NRC RAI 1-1

Indicate groove weld size that can be used interchangeably with fillet welds.

Holtec's response to RAI 1-1

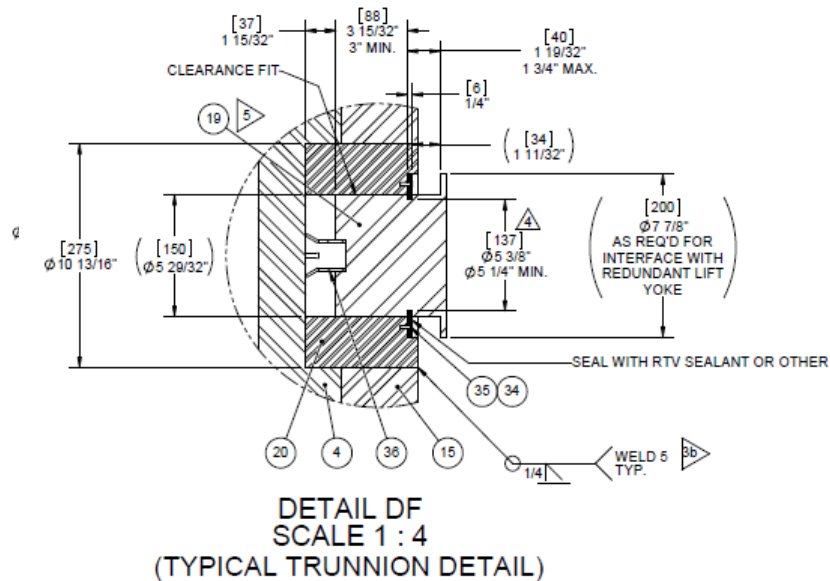
Clarify the dimensions of the trunnion keeper plate (BOM item 34) and the trunnion (BOM item 19).

Lifting calculations contained in document HI-2177540RO indicate that the trunnion keeper plate length is 0.25in; however, there are no dimensions of this part on the licensing drawings. While the trunnion keeper plate is NITS, it does affect the overall length of the trunnion (ITS) since the axial length of the trunnion is specified relative to the trunnion keeper plate.

Additionally, lifting calculations do not appear to consider the trunnion keeper plate's protrusion into the trunnion. As drawn, it appears that the entire cross section of the trunnion cannot be used for lifting calculations as relied upon in document HI-2177540R0 due to the trunnions keeper plate location.

Provide the axial length of the trunnion and trunnion keeper plate dimensions on the licensing drawings and revise the lifting calculations, as necessary, for a reduced available cross-section due to the trunnion keeper plate.

The trunnion and trunnion keeper plate dimensions are revised, as shown below, to indicate the minimum cross-section of the trunnion, the cantilevered length of the trunnion and the thickness of the keeper plate. The updated licensing drawing is included in Section 1.3 of the SAR.

Figure M224-1. Typical failure curve for metal sheet, modeled with shell elements.

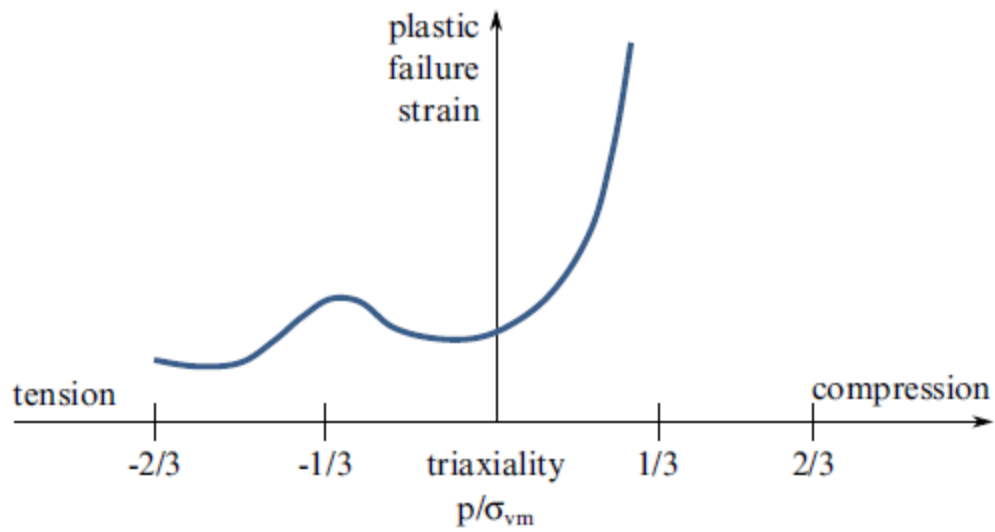
Clarify the triaxiality values used to predict material failure in LS-DYNA simulations.

Clarify these values and/or update all LS-DYNA drop and puncture simulations for both normal and accident conditions since element failure can potentially result in breaches in the containment boundary due to material failure.

- a. The triaxiality factor (TF) is computed as a negative value if the triaxial stress-state in the element is in tension and vise-versa (see Figure 1 below from LS-DYNA User Manual).
- b. The TF magnitude differs between LS-DYNA and ASME by a factor of 1/3.

For example, if the triaxiality factor per ASME is 1, LS-DYNA computes it as -1/3. Likewise, a TF of 2 per ASME relates to -2/3 in LS-DYNA.

A new appendix is added to the calculation HI-2177539 documenting the material behavior.

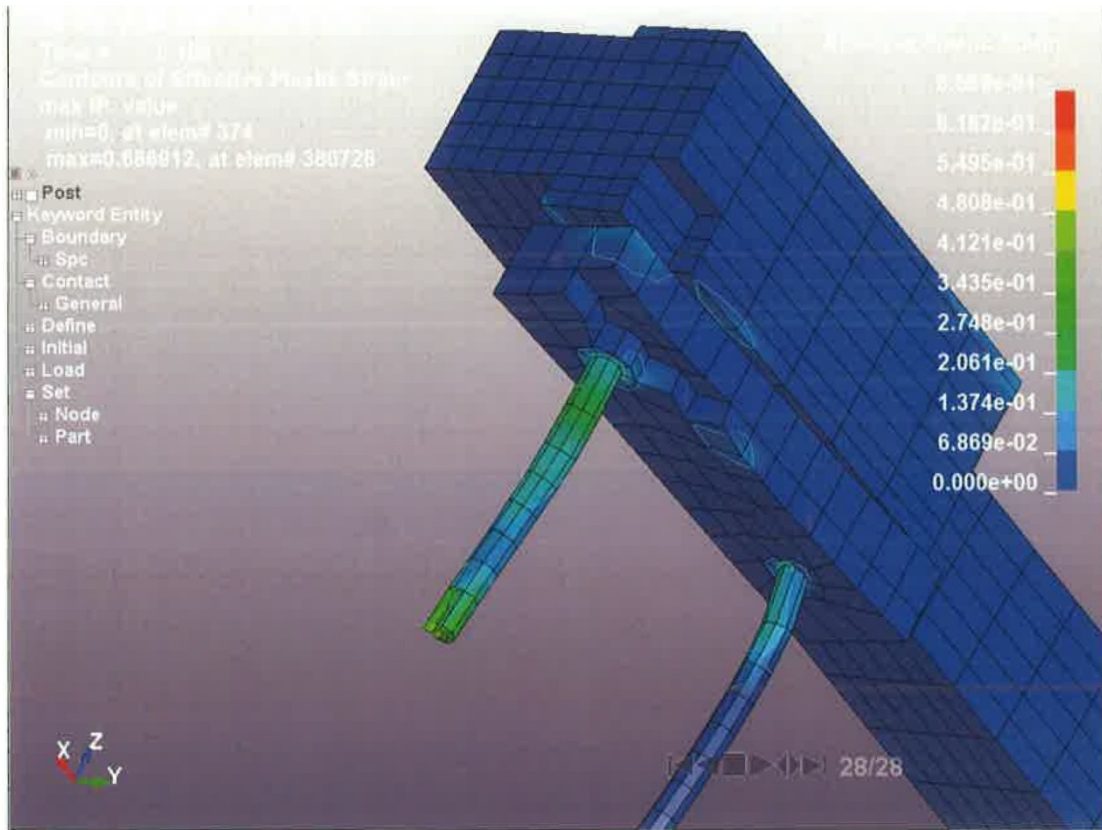
Clarify the dimensions and the modeled properties of the cask wedge blocks depicted on licensing drawings used in LS-DYNA simulations for both the prototype and ATB 1T. Sheet 2 of Drawing 9786 of the ATB 1T depicts cask wedge blocks (BOM 11) in relationship to the top flange (BOM 2) under the view "closure lid wedge system". It appears that the cask wedge blocks are tapered 4° and forced against an equally tapered 4° closure lid locking wedge (BOM 9 and 10).

According to Section 2.3 of the application, shims will also be installed against the cask wedge blocks. This similarly applies to the prototype as well, as shims were used at the location of the wedge blocks. Since the cask wedge blocks help maintain a positive closure on the seals of the package:

- a) Describe why wedge blocks (BOM 9 and 10) are not modeled with a 4° taper.
- b) Provide the compressive stress (sealing force) expected on the seals (BOM 7) and the sealing surface of the flange (BOM 2) when the lid (BOM 8) is fully engaged by closure lid locking wedges (BOM 9 and 10). The expected compressive force (if any) should be incorporated into LS-DYNA simulations, supported by calculation, and tractable with respect to an installation procedure.

The full simulation model is revised to consider the tapered geometry of the wedge blocks with an approximate 4 degree angle.

With respect to the LS-DYNA benchmark simulations of the 1/4-scale drop tests, the shims are not explicitly modeled as individual components. Instead the dimensions of the cask wedge blocks (BOM 11) are adjusted in the FE model to achieve a zero gap between the closure lid locking wedges (BOM 9 and 10) and the cask wedge blocks at the start of the simulation. This modeling simplification is considered acceptable since the objective of the benchmark analysis is to numerically predict with reasonable accuracy the global response of the package in terms of its deceleration response, permanent deformations, and strain levels in the containment boundary, which does not require detailed modeling of shims as evident by the simulation results.

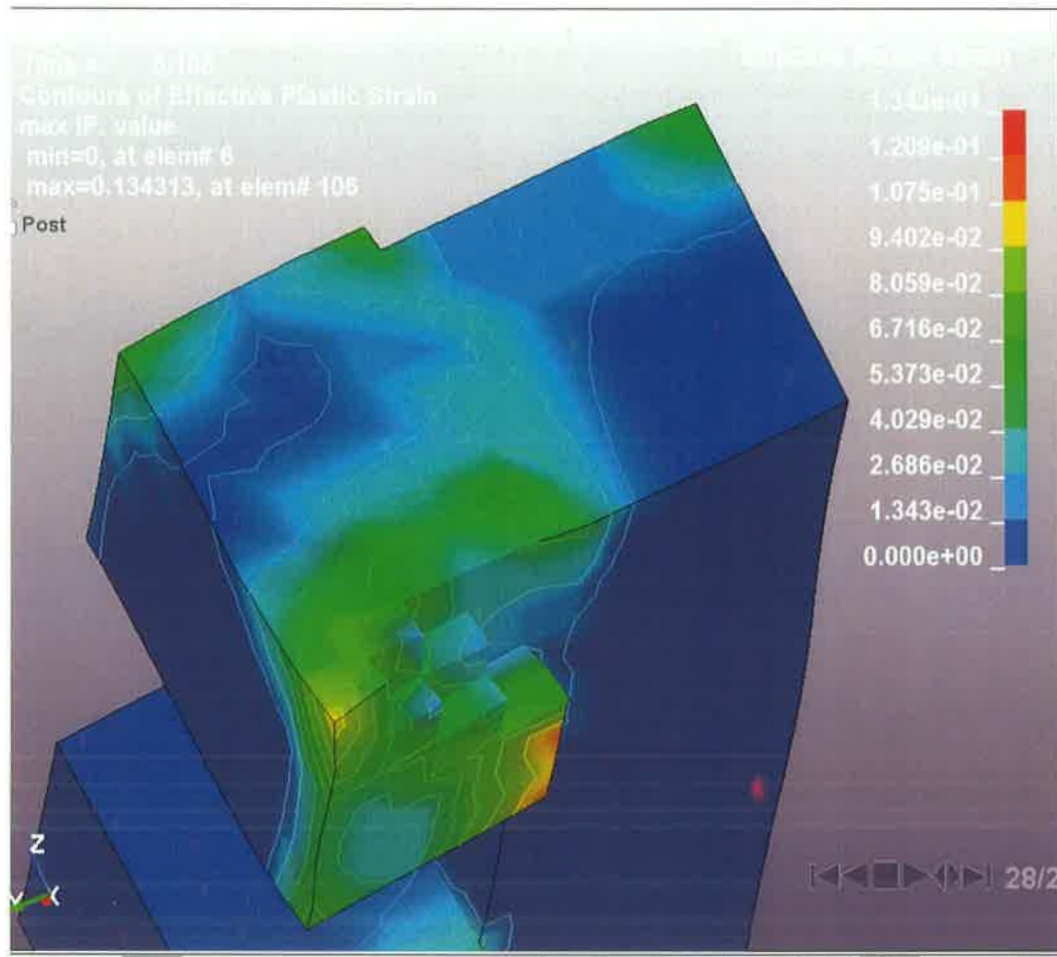
Clarify and justify the acceptance criteria used for the closure lid locking mechanisms and how this part is modeled in LS-DYNA.

Section 2.1.2.2 of the application states that the acceptance criteria for the closure lid locking mechanism is such that it should not undergo gross yielding. For at least one LS-DYNA simulation, the 30ft oblique drop appears to depict gross yielding of the closure lid locking wedge along with some material failure. The missing material is depicted below:

Gross yielding is assumed here to have occurred because a plane can be passed through the end of CLLS, and encounter effective plastic strain throughout that plane.

Clarify how this acceptance criteria is met in this instance and why the criteria is valid. It could be argued that the CLLS can undergo partial inelastic yielding (not gross) and cause a breach in containment. For instance, one face of the CLLS could suffer uniform material failure allowing the lid to become loose.

This RAI does not have any effect on the 1/4-scale drop simulations documented in Holtec report HI-2167517. Only limited plastic strain is observed in the CLLS in the quarter scale drop simulations from the oblique drop. The prototype drop tests and the corresponding benchmark simulations further demonstrates the CLLS is very well protected from failure and provide high level confidence against the containment breach.

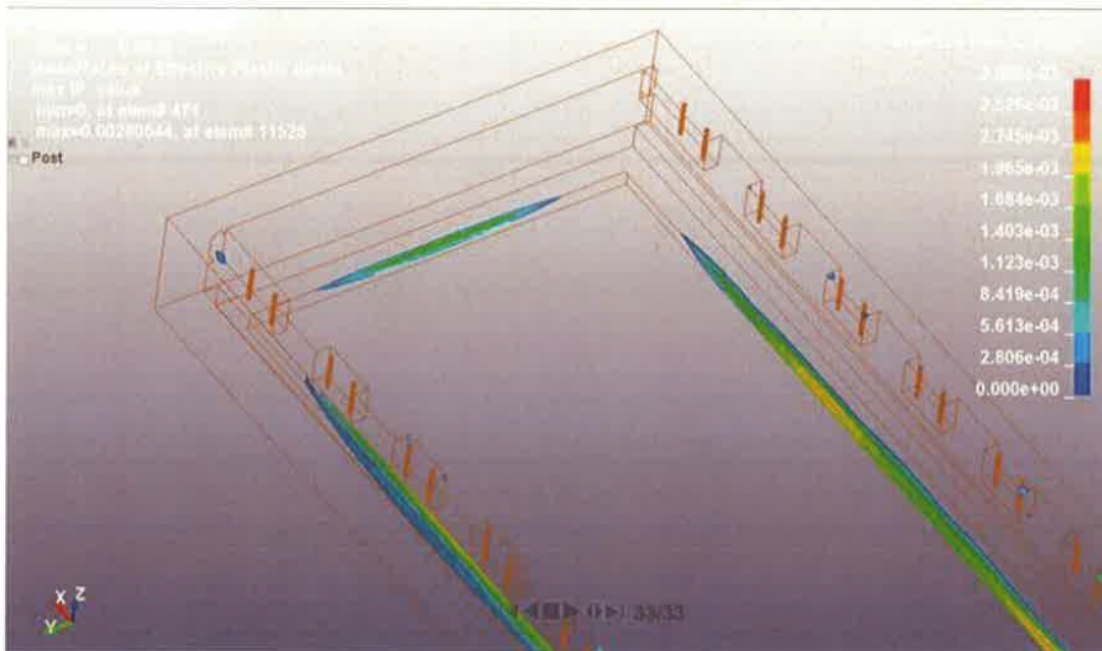
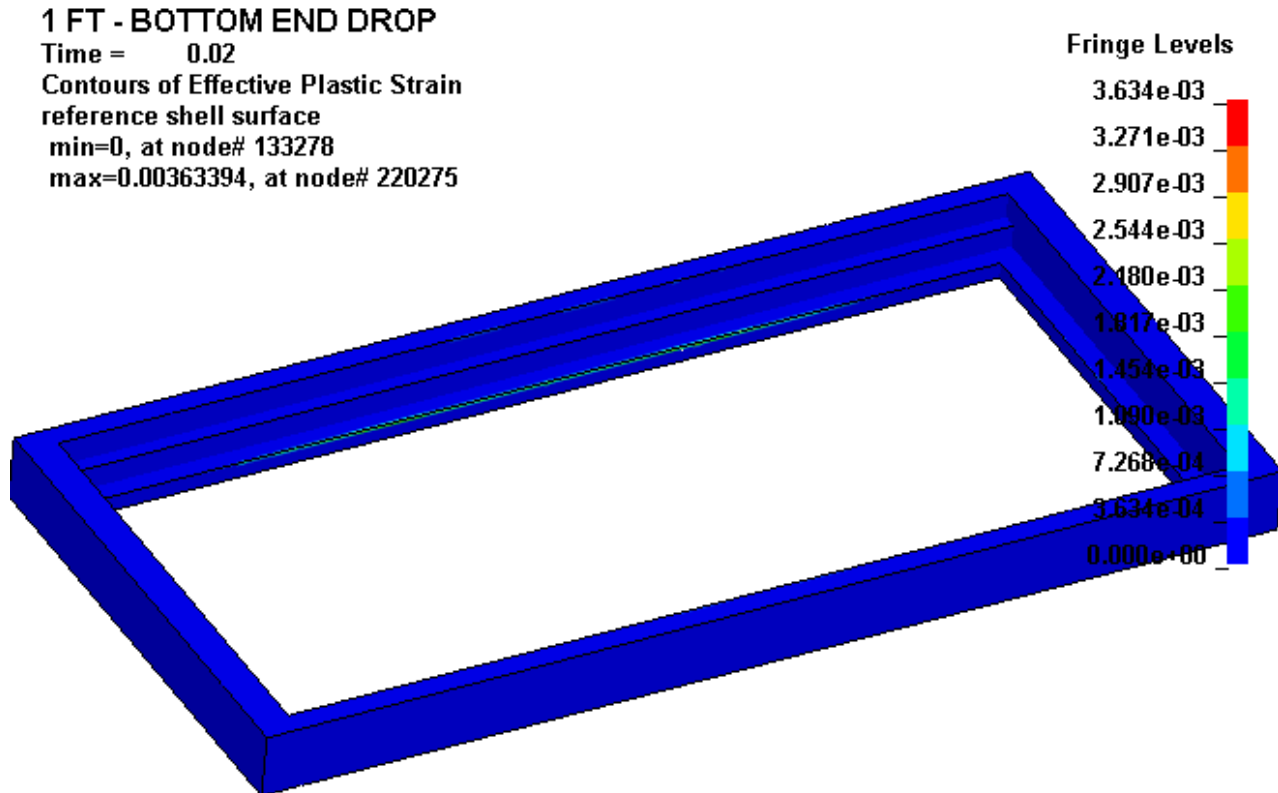
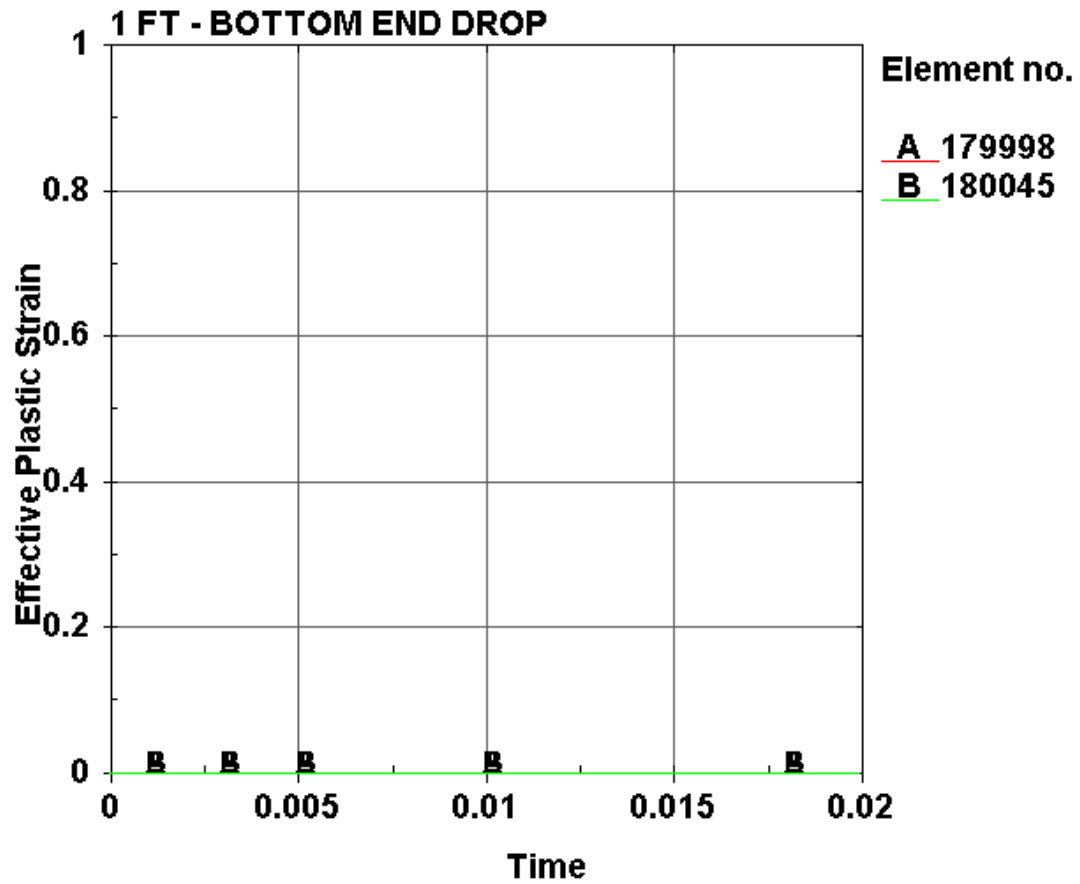
Verify the modeling of the top flange landing and package contents.

Page 2-8 of the application mentions that strain-based criteria cannot be applied to the landing area of the top flange (BOM 2) and of the closure lid (classified as Zone B). LS- DYNA simulations for both the bottom end 1 ft drop (NCT) and 30 ft bottom end drop (HAC) report inelastic deformations around the flange landing as depicted below (1 ft bottom end drop shown):

The flange landing in LS DYNA has been modeled as 3.125" wide, where in the licensing drawings the landing is depicted as being only 2.5" wide. It is expected that, if a value of 2.5" had been used, higher degrees of inelastic deformation would have been reported by LS-DYNA.

- a) Update LS-DYNA puncture and free drop model with regards to flange dimensions,
- b) Describe the seal/flange landing performance as a function of rigid body assumptions.

The flange landing width is corrected in the updated simulations.

Also, in the updated simulations the BFA tank enclosing the BFA Tank cassette is represented by an elastic-plastic body allowing the closure lid to deflect fully under the severe drop accidents.

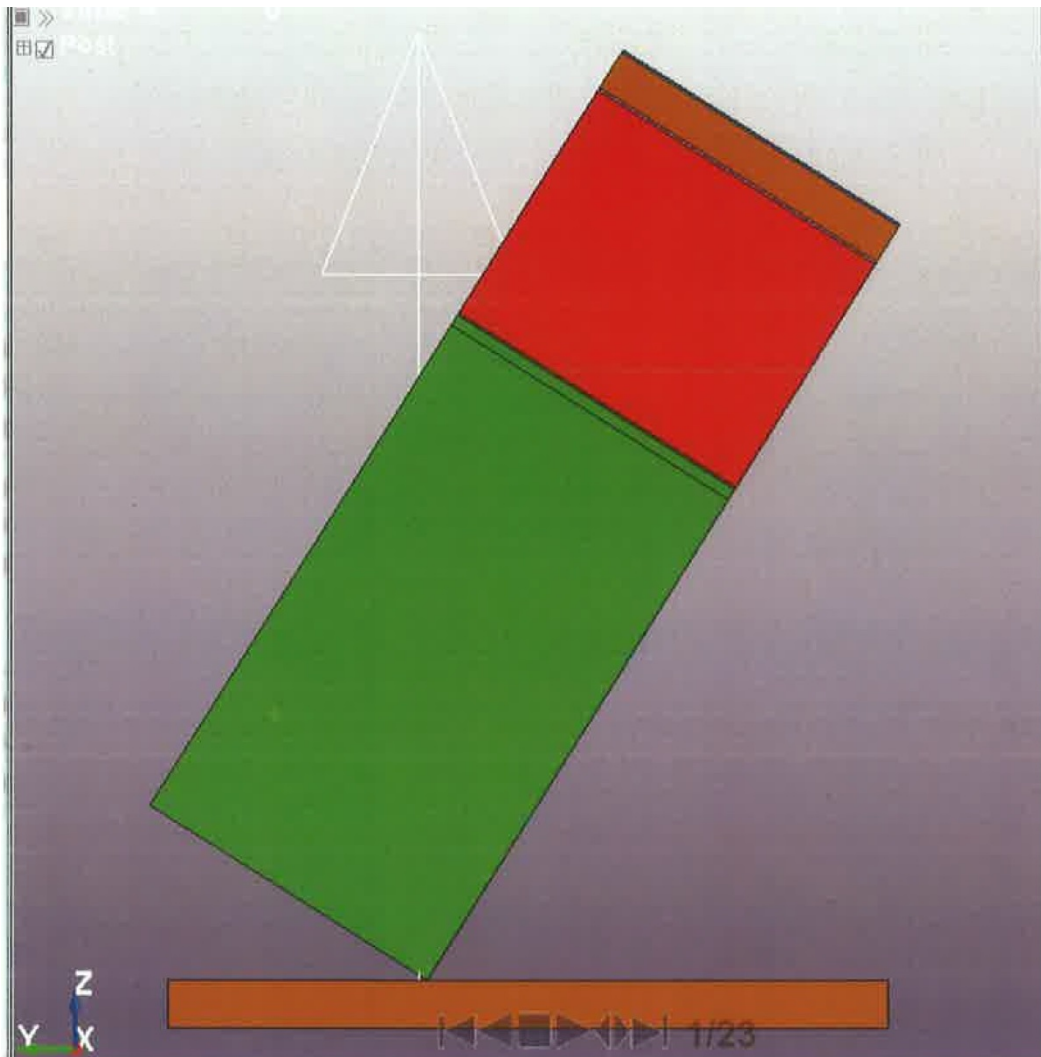
Verify that the HI-STAR ATB 1T orientation was correct when conducting CGOC simulations in LS-DYNA for NCT and HAC.

The HI-STAR ATB 1T center of gravity is located relatively close to its geometric center. An arrow drawn normal to the target and close to the point of impact should pass through the center of gravity. It is expected that this fictitious arrow would pass through the center of gravity and close to the opposing corner of the package.

Verify that the package orientation for the CGOC simulation is correct.

This comment has no bearing on the 1/4-scale drop simulations documented in Holtec report HI-2167517 since the package orientations accurately reflect the drop test measurements.

Figure 3-1.1: Schematic of Levitating Cask Configuration

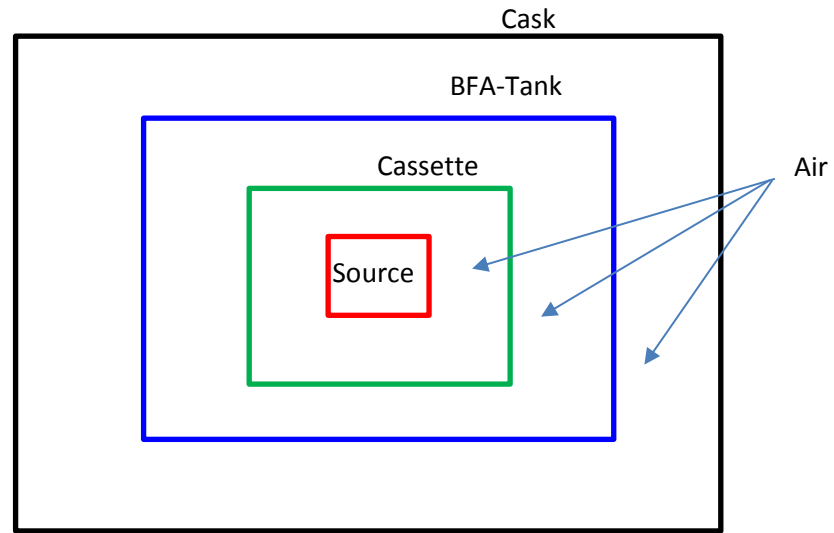
Clarify the bounding heat load distribution for the NCT and HAC thermal analyses so that a review of maximum package temperatures can be performed.

The uniform heat distribution model as explained in the following is bounding for licensing basis evaluation. The objective of thermal modeling is two-fold wherein one scenario is defined to maximize computed temperatures of the radioactive source inside the cassette as shown in Figure 3-1.1 and a second scenario defined to maximize cavity temperatures and co-incident containment pressures. Under the first scenario the radioactive source is assumed to be concentrated in a block of solid metal equal to the mass of the source materials and levitating in air as shown in Figure 1. In the second case the source material is assumed uniformly distributed within the cassette space with the objective of maximizing cavity temperatures. To construct a licensing basis model that bounds both scenarios an effective conductivity of the cassette interior space under the second scenario is determined to yield the *same* maximum temperature obtained in the first scenario. This calibrated thermal model defined as "uniform heat distribution" model is adopted for Normal Conditions of Transport (NCT) evaluations.

Under Hypothetical Accident Conditions (HAC) of transport a conservative construct is postulated wherein the BFA-tank and the radioactive contents are assumed to be distributed in the cask cavity to maximize containment pressures. The effective conductivity of the cavity space is calibrated to yield the maximum source temperatures obtained under concentrated heat distribution scenario defined above. In this manner a bounding model is obtained and adopted for HAC evaluation.

In light of the above discussion SAR Section 3.3.10 is suitably revised for clarity.

Figure 3-4.1 Residuals for NCT

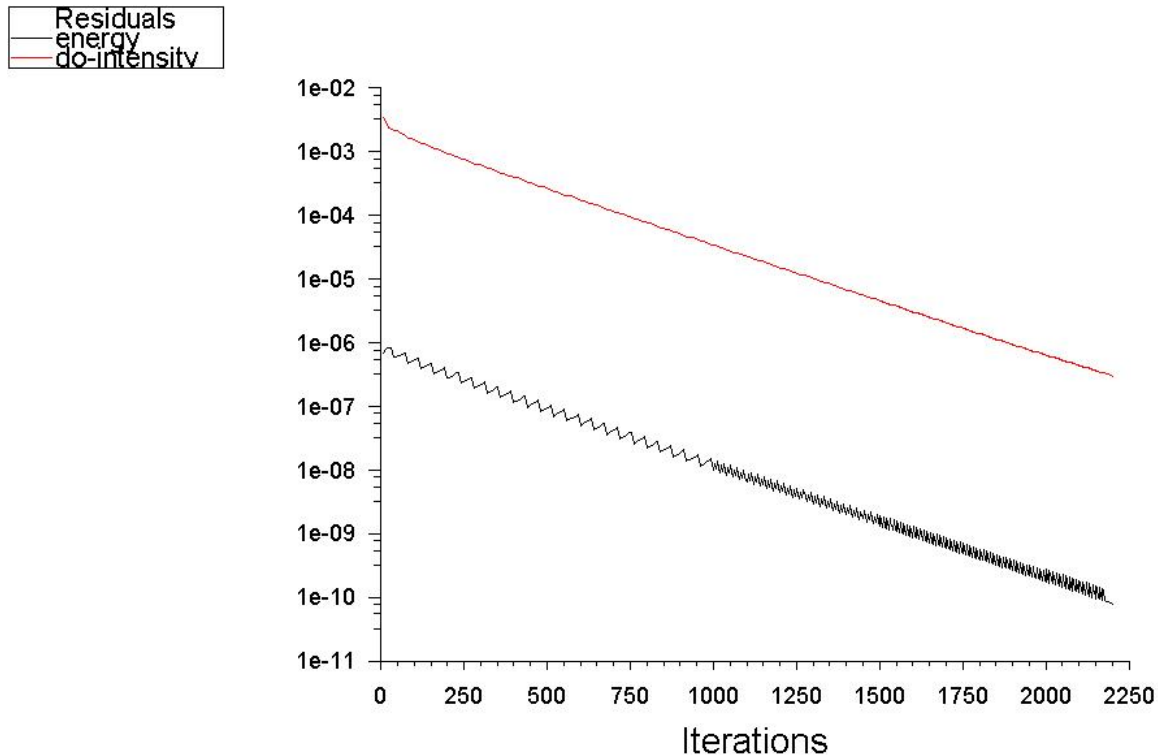
Provide the residuals and energy balances for the NCT and HAC thermal analyses.

As requested, the residuals are graphed in Figure 3-4.1 for normal conditions of transport.
